REMARKS

B. Drawings

During the course of Applicant's review of the specification and drawings in preparation for responding to the Official Action, Applicant discovered the informalities identified below in the drawings. Accordingly, applicant requests permission to amend the drawings in the following manners:

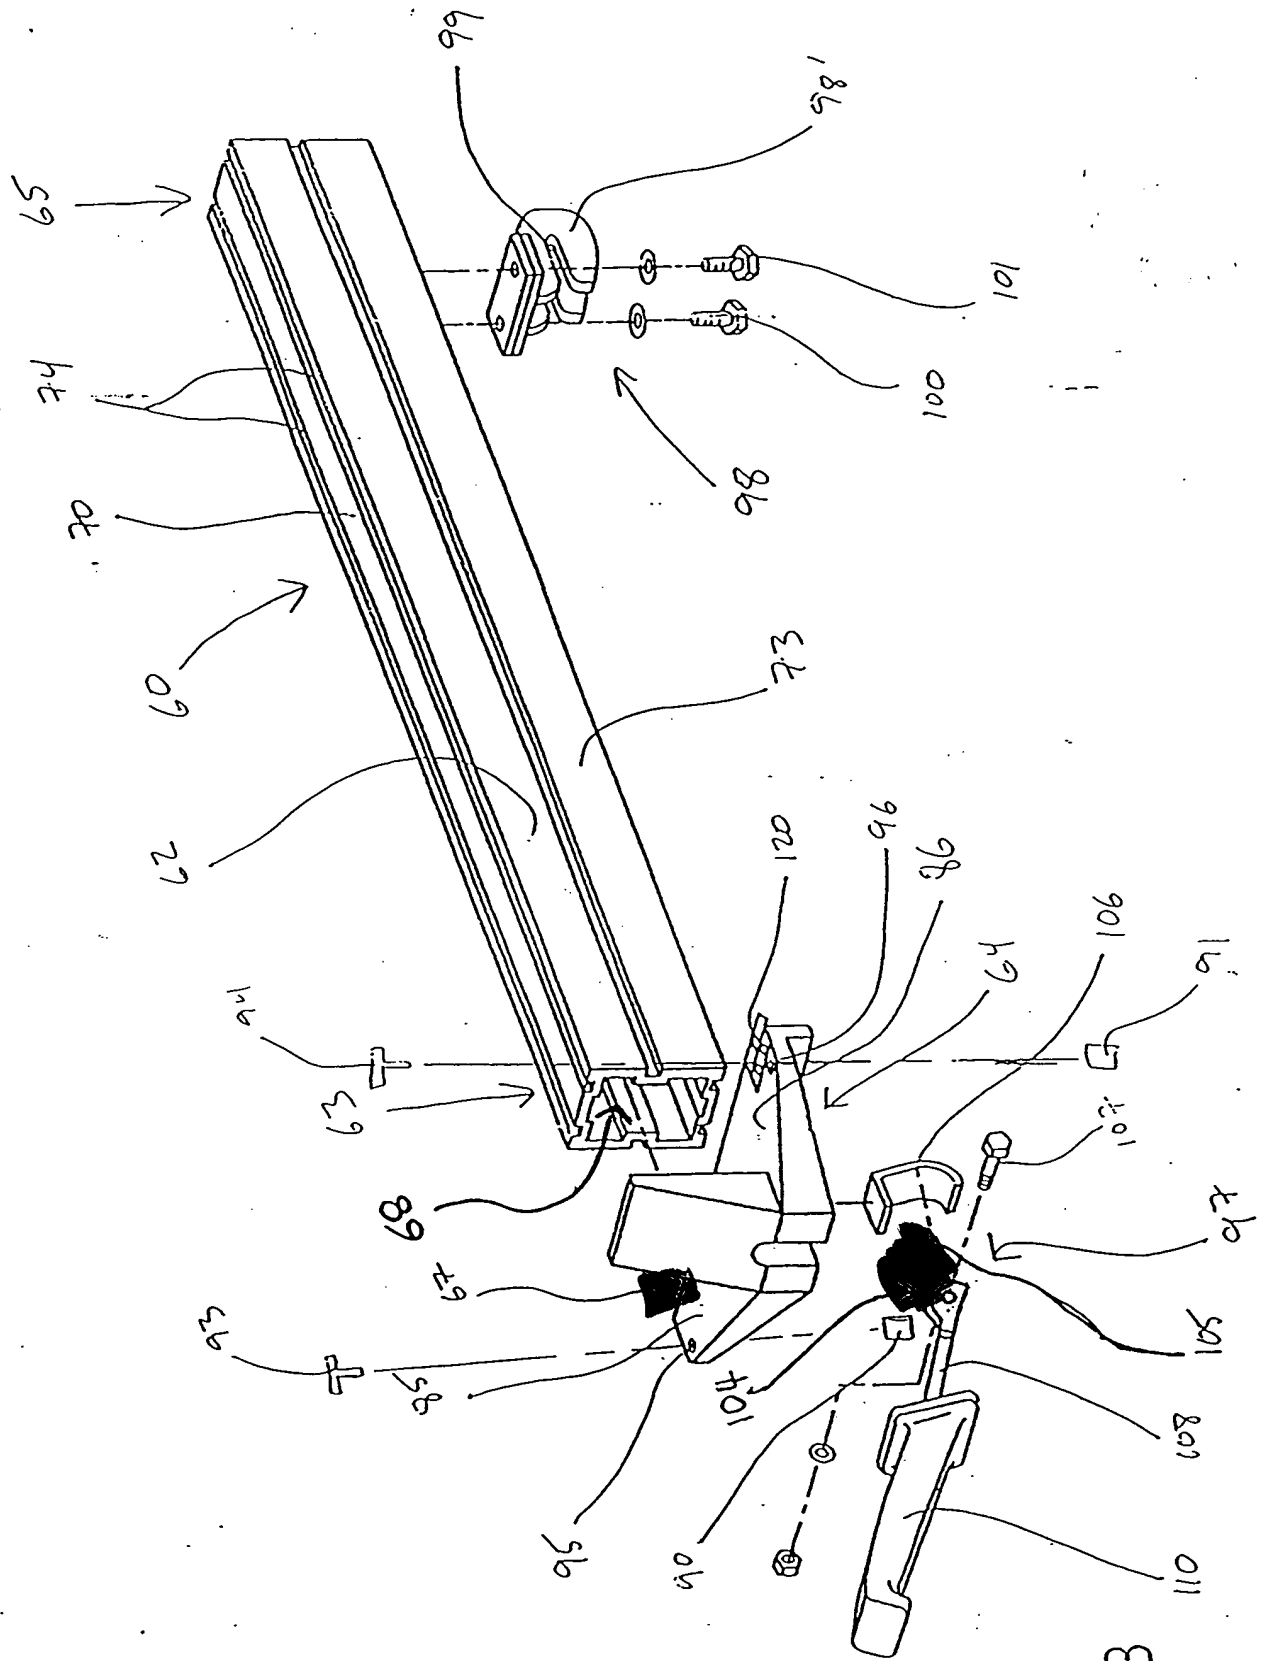
Figure 13: Reference number "67" lead line amended to terminate without an arrow and redirected to point to proper element surface.

Reference number "104" lead line amended to terminate with an arrow.

Reference number "105" lead line amended to terminate without an arrow.

FIG. 14

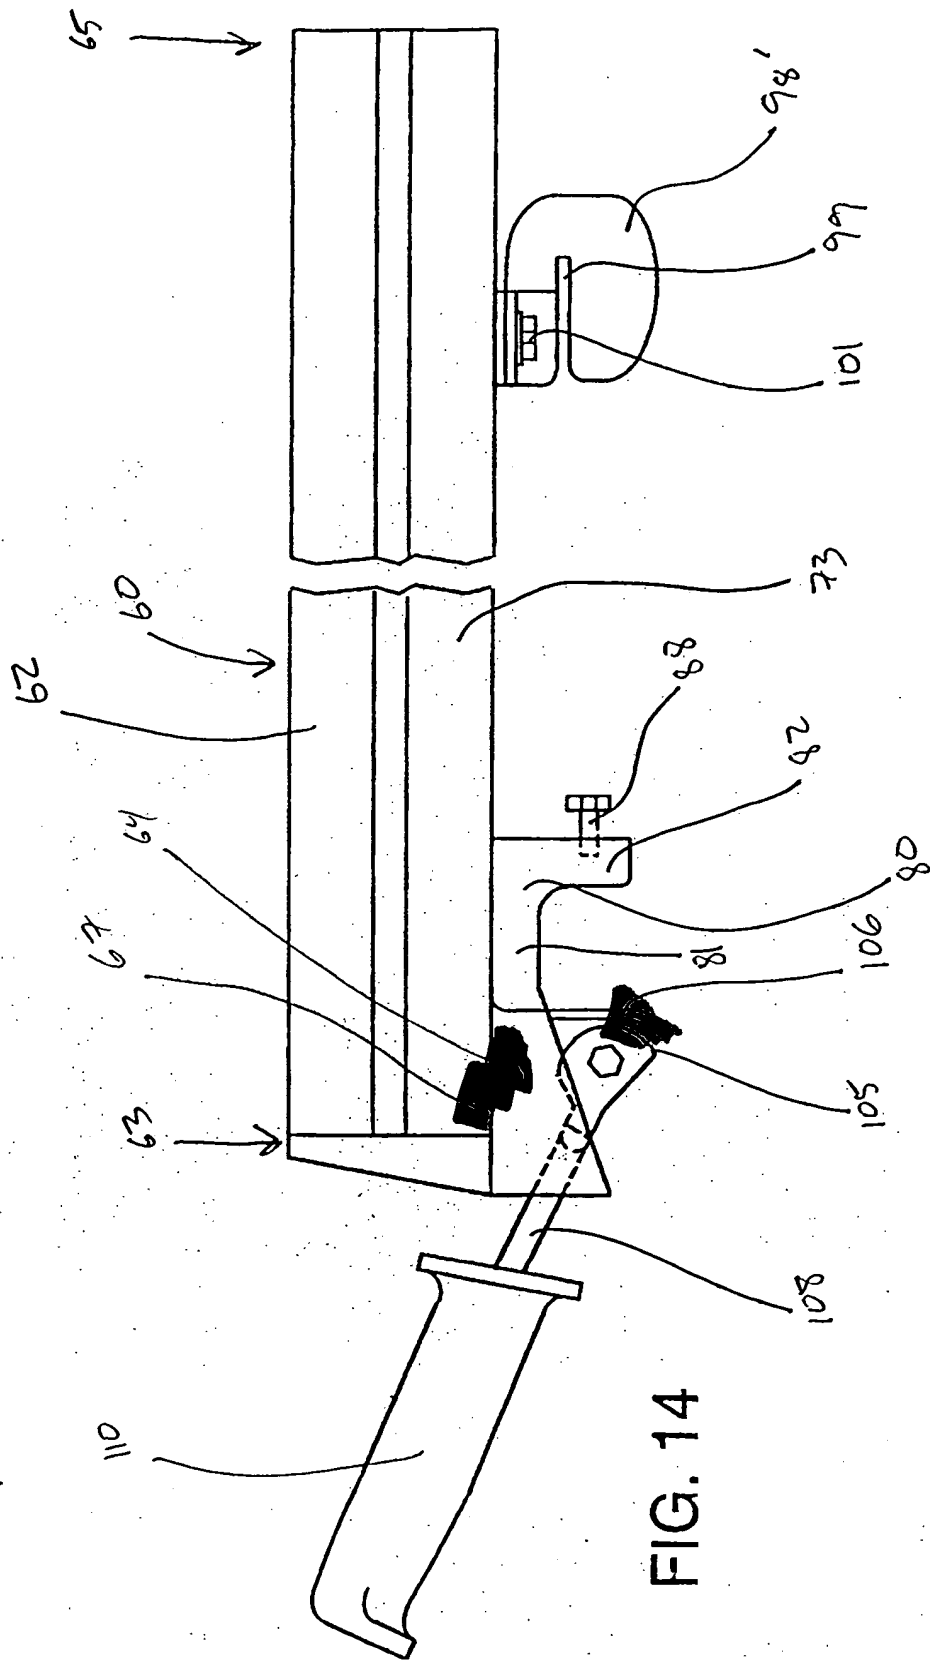
Figure 14: Reference number "67" lead line amended to terminate without an arrow.

Reference number "64" lead line amended to terminate with an arrow.

Reference number "105" lead line redirected to point to the proper element surface.

FIG. 16

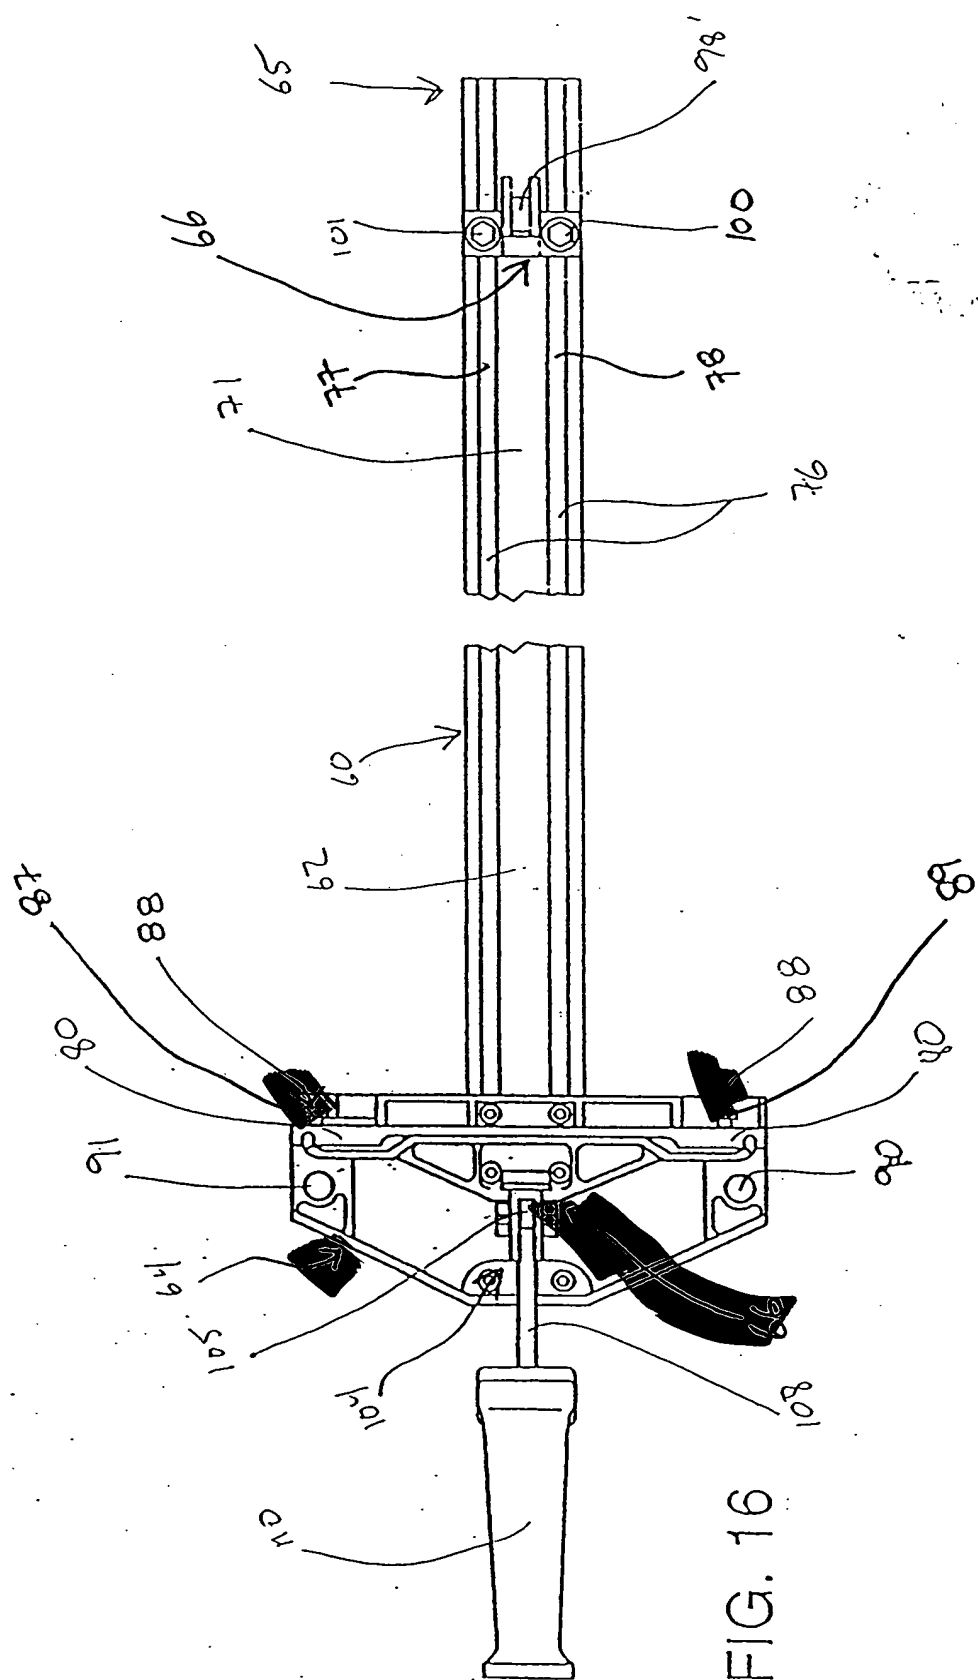
Figure 16: Reference number "64" lead line amended to terminate with an arrow and redirected to point to the proper element.

Reference number "88" lead lines both amended to terminate with an arrow.

Reference number "66" added with a lead line terminating with an arrow to show the element as supported in the original disclosure.

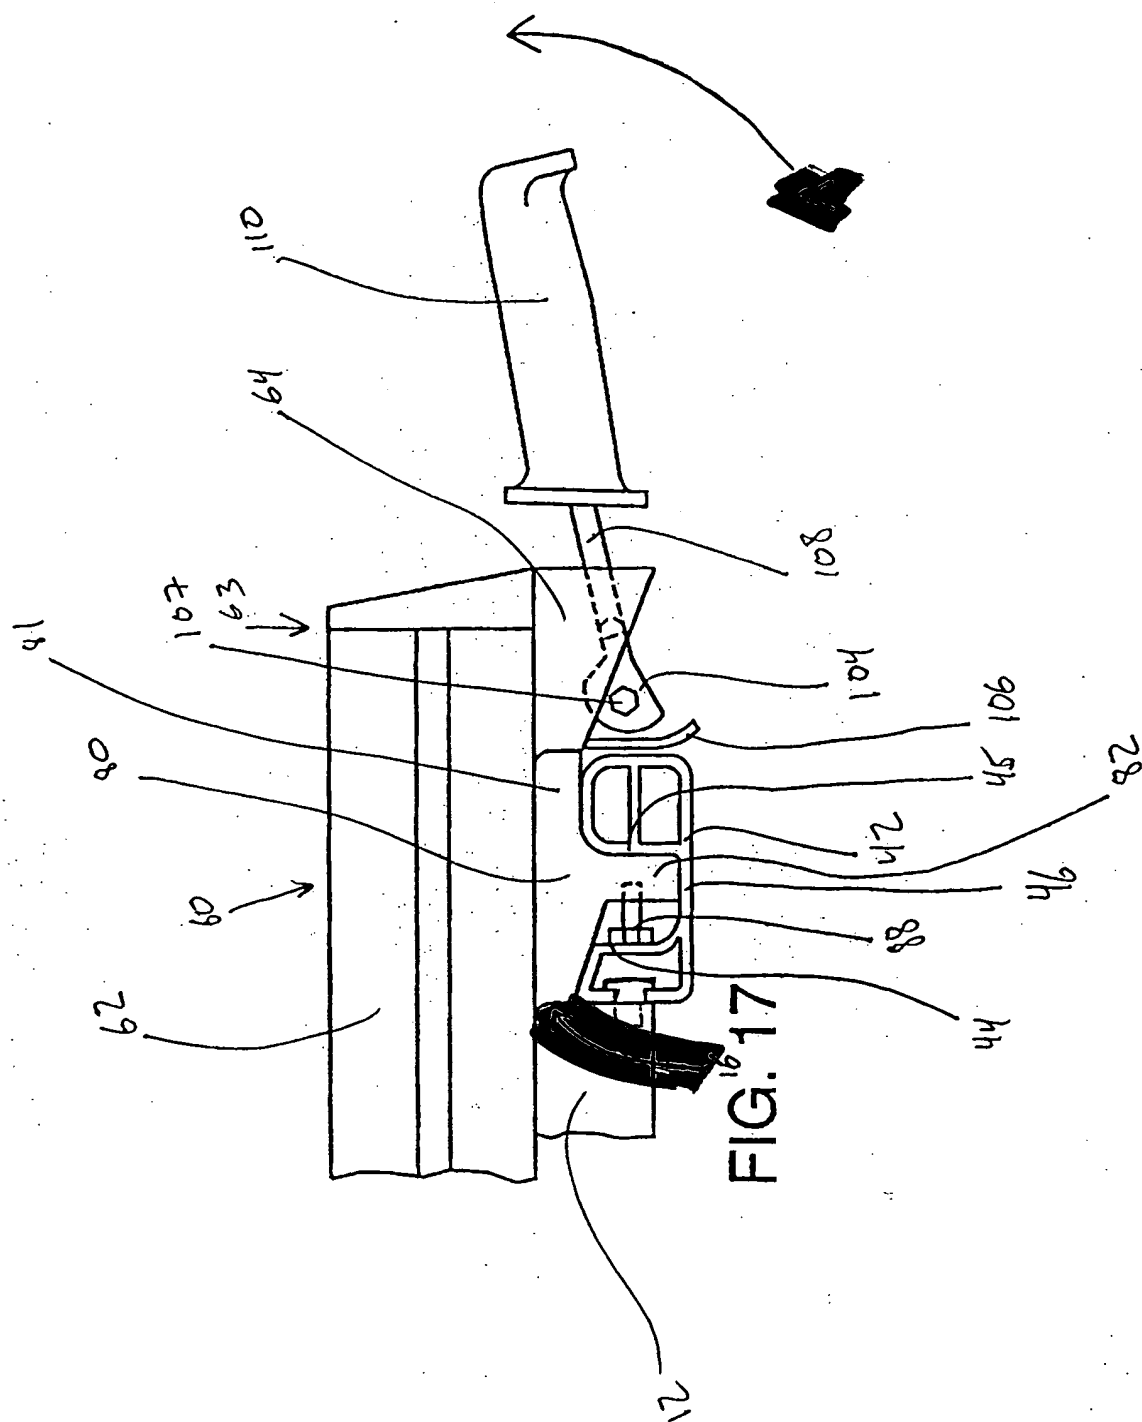
Figure 17: Reference number "16" lead line redirected to point to proper element surface.

Reference letter "A" added to the curved lead line terminating with an arrow to show the directional movement described in the original disclosure.

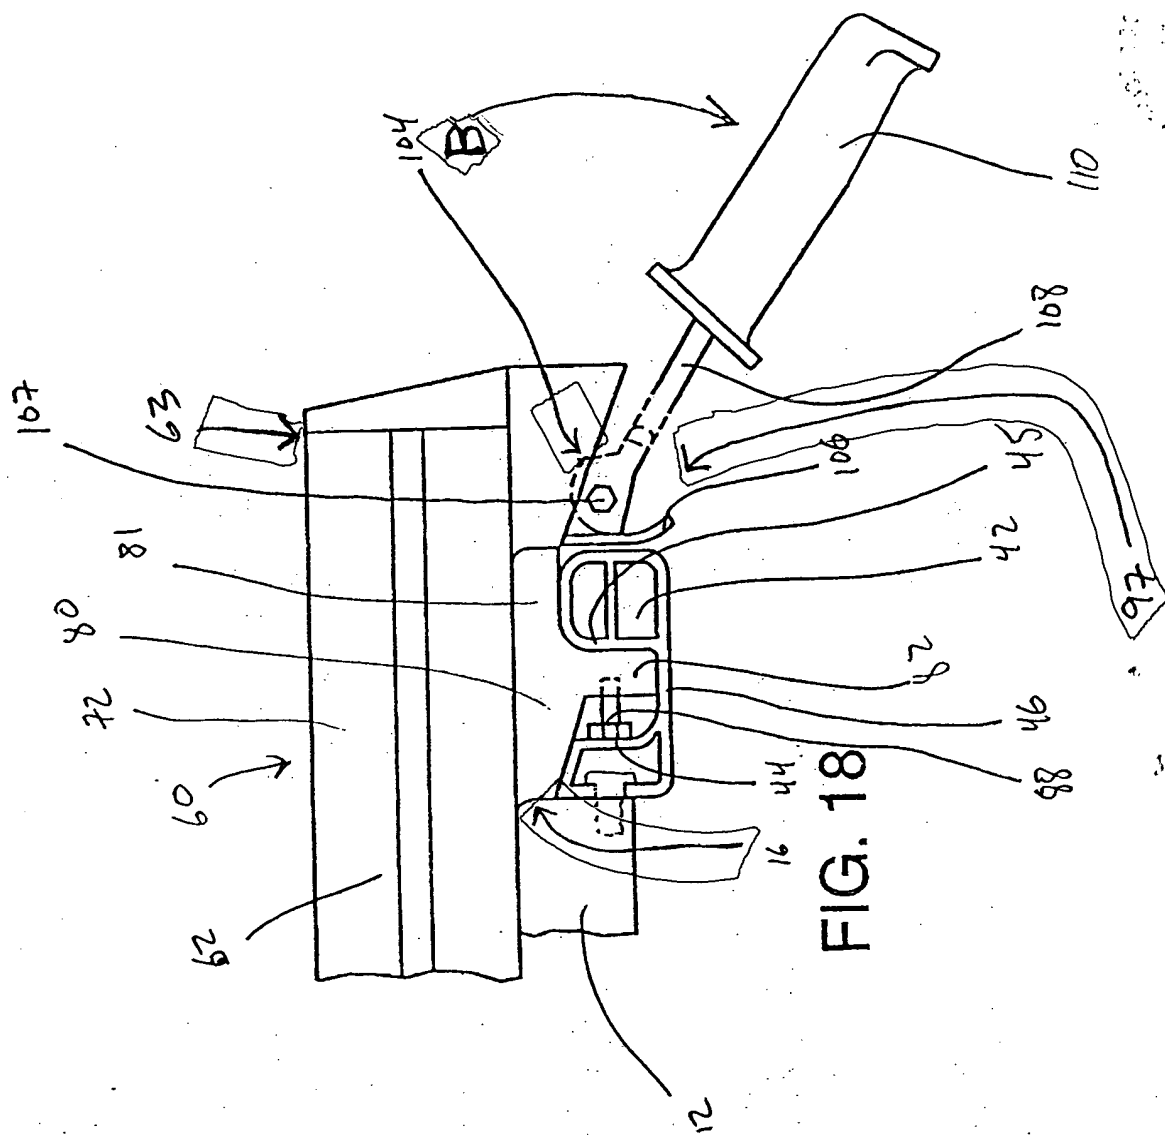
Figure 18: Reference number "16" lead line redirected to point to proper element surface.

Reference number "97" lead line redirected to point to the proper element.

Reference letter "B" added to the curved lead line terminating with an arrow to show the directional movement described in the original disclosure.

Reference number "104" lead line amended to terminate with an arrow.

Reference number "63" lead line redirected to point to the proper element.

FIG. 19

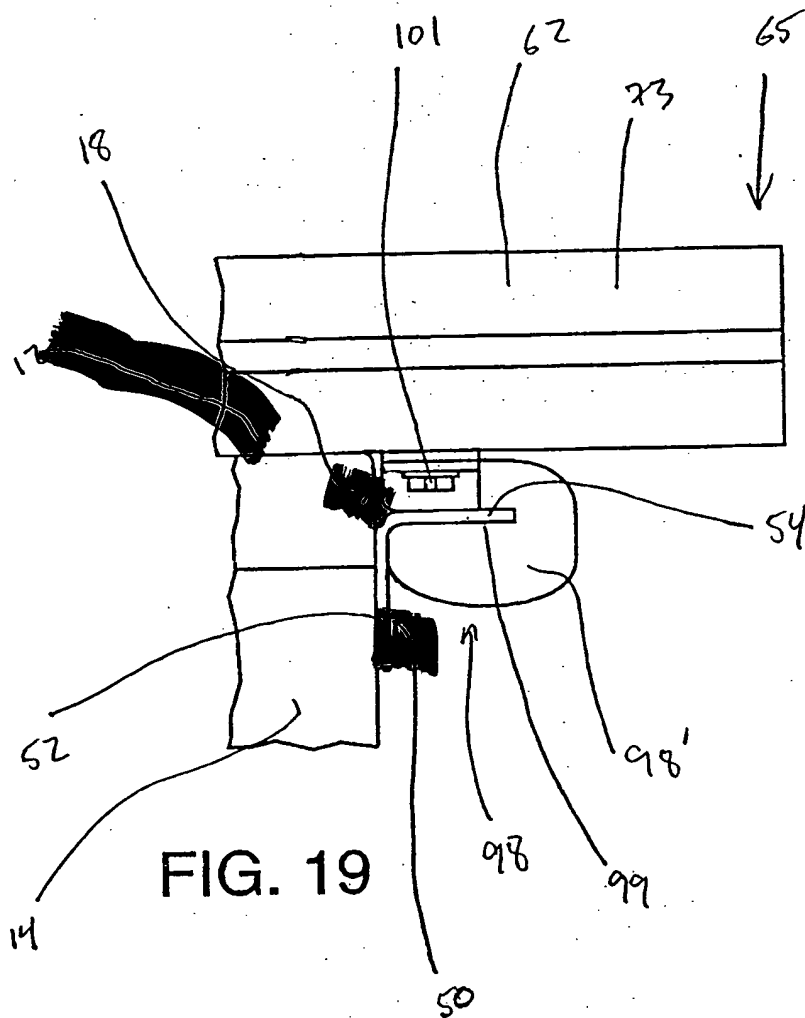
Figure 19: Reference number "12" lead line redirected to point to proper element surface.

Reference number "18" amended to terminate with an arrow and to point to proper element surface.

Reference number "50" lead line amended to terminate with an arrow.
